**IEEE 802.3 Ethernet Working Group  
Liaison Communication**

Subject: Liaison letter ITU-T SG15 to IEEE 802.3 LS 1

## Annex 31A

Annex 31C

Figure 31C–1—MAC Control EXTENSION Frame

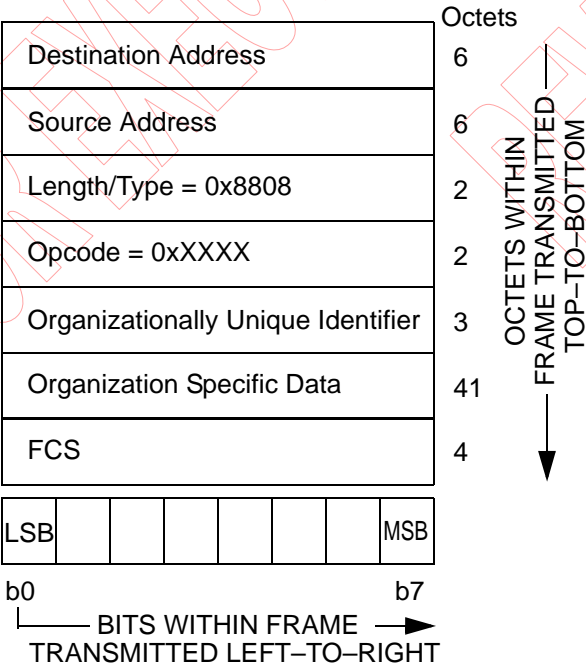
31C.2 Transmission of Extension MAC Control frame

Upon receipt of a MA\_CONTROL.request primitive containing the EXTENSION opcode from a MAC client, the MAC control sublayer calls the MAC sublayer MAC:MA\_DATA.request service primitive with the following parameters:

- a) The destination\_address is set equal to the destination\_address parameter of the MA\_CONTROL.request primitive. This parameter is currently restricted to either the value 01-80-C2-00-00-01 or to the 48-bit individual address of the destination station.
- b) The source\_address is set equal to the 48-bit individual address of the station.
- c) The length/type field (i.e., the first two octets) within the mac\_service\_data\_unit parameter is set to the IEEE 802.3 MAC Control type value assigned in @@Subclause 31.4.1.3@@.
- d) The remainder of the mac\_service\_data\_unit is set equal to the concatenation of the Extension Opcode, the Organizationally Unique Identifier, and the Organization specific data.
- e) The frame\_check\_sequence is omitted.

**Figure 31C-2—EXTENSION receive function**

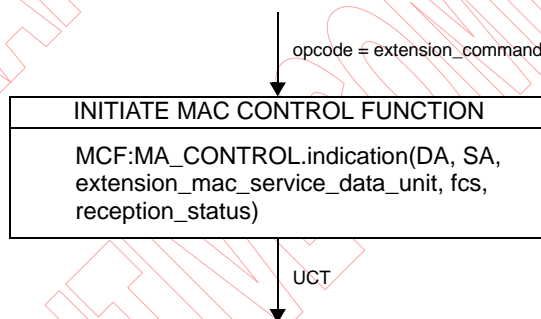
#### 31C.3.1 Receive state diagram (INITIATE MAC CONTROL FUNCTION) for EXTENSION operation

@@Figure 31C-2@@ depicts the INITIATE MAC CONTROL FUNCTION for the EXTENSION operation (See @@Subclause 31.5.3@@). Upon reception of EXTENSION frames, the frame is sent to the MAC CONTROL client.
